**TOWN OF NEWBURGH
PLANNING BOARD
TECHNICAL REVIEW COMMENTS**

PROJECT: MAHER – 50 COCOA LANE
PROJECT NO.: 21-09
PROJECT LOCATION: SECTION 34, BLOCK 2, LOT 71.34
REVIEW DATE: 28 MAY 2021
MEETING DATE: 3 JUNE 2021
PROJECT REPRESENTATIVE: ENGINEERING & SURVEYING PROPERTIES

**RE: W.O. # 1325.02
PB APPLICATION 2021-09
MAHER – COCOA LANE
50 COCOA LANE
COMMENT RESPONSE**

ABSORPTION TILE FIELD OVERALL PLAN

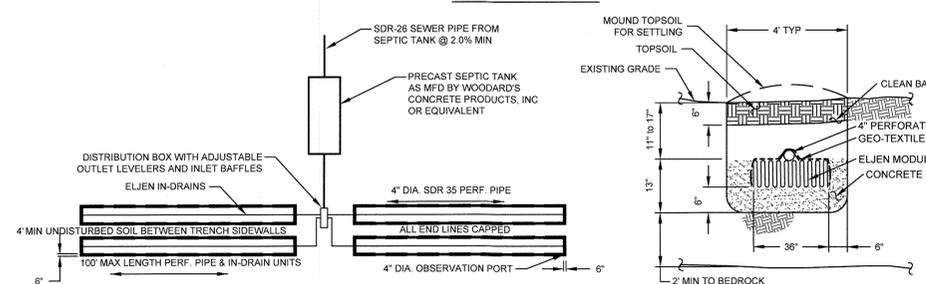
5. Detail "Absorption Tile Field Overall Plan" on Sheet C-2 has a "Typical Eljen Trench Section" which specifies the use of concrete sand.
